FARRAGUT MUNICIPAL PLANNING COMMISSION AGENDA

July 15, 2021 – 7:00 p.m.
Farragut Town Hall
Board Room

REPORT TO THE FARRAGUT MUNICIPAL PLANNING COMMISSION

SHEET C-1 (2 OF 18)

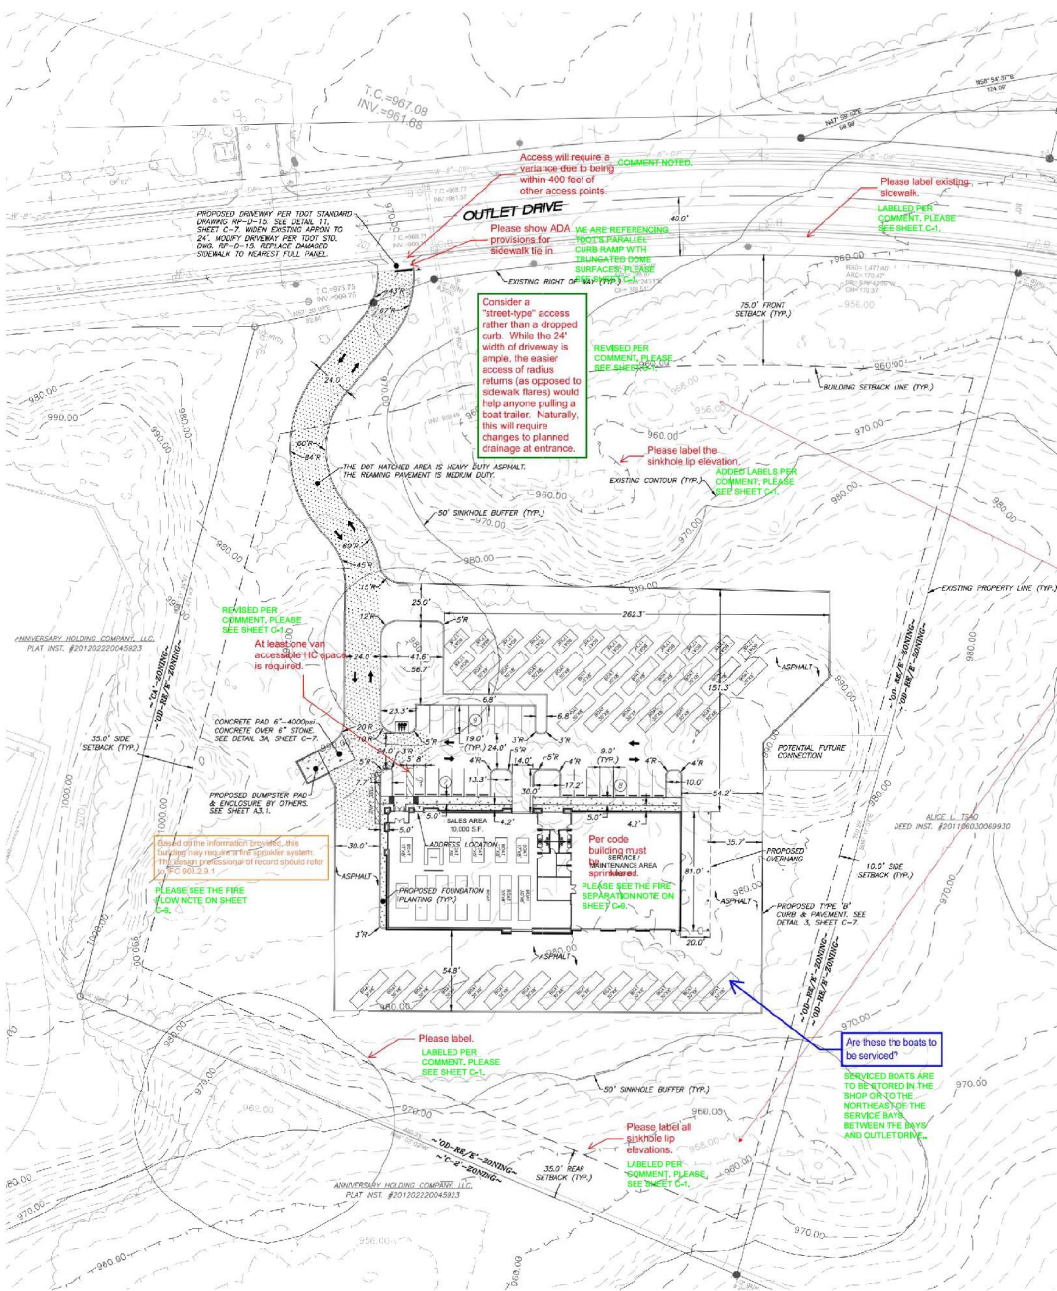
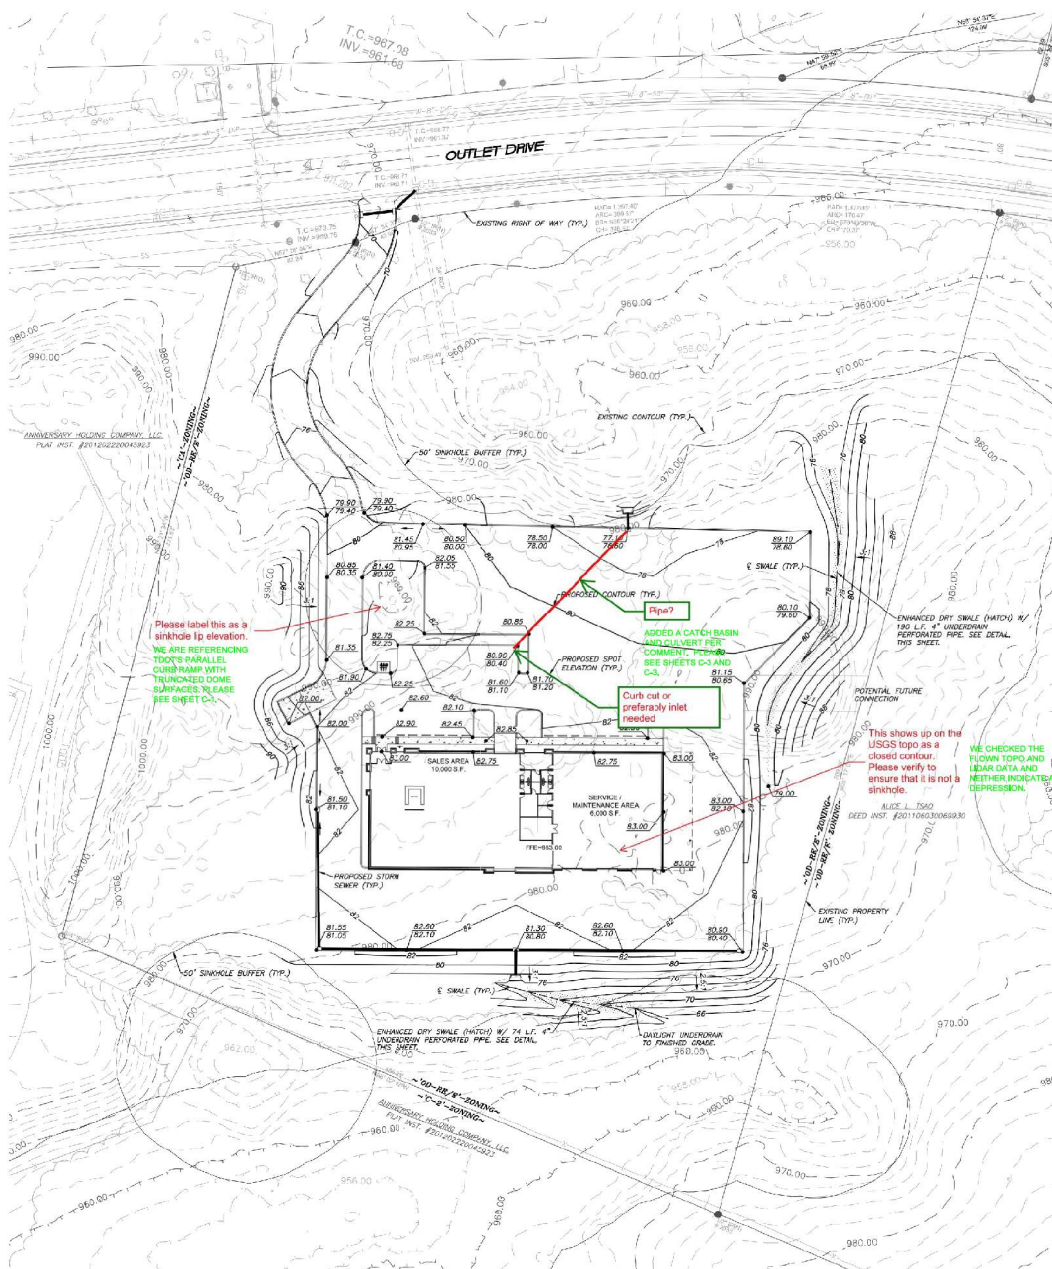
PLEASE SEE NOTE 18 ON SHEET C-1 AND NOTE 15 ON SHEET C-2.

SHEET C-4 (5 OF 18)

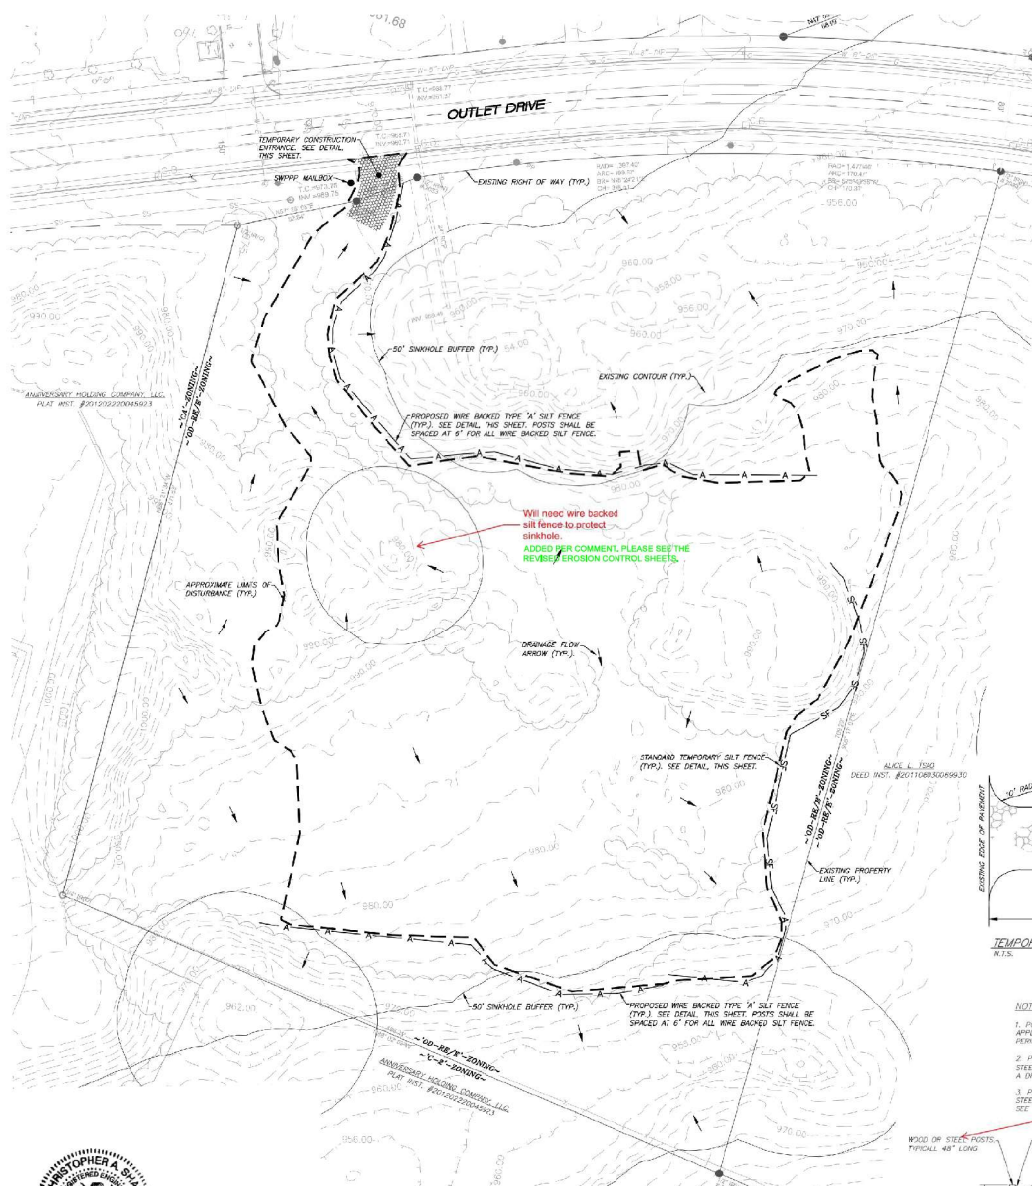
PLEASE USE ONLY STEEL DOSS FOR THE WIRE BACKED SILT FENCE.
REVISED PER COMMENT, PLEASE SEE THE REVISION EROSION CONTROL SHEETS.
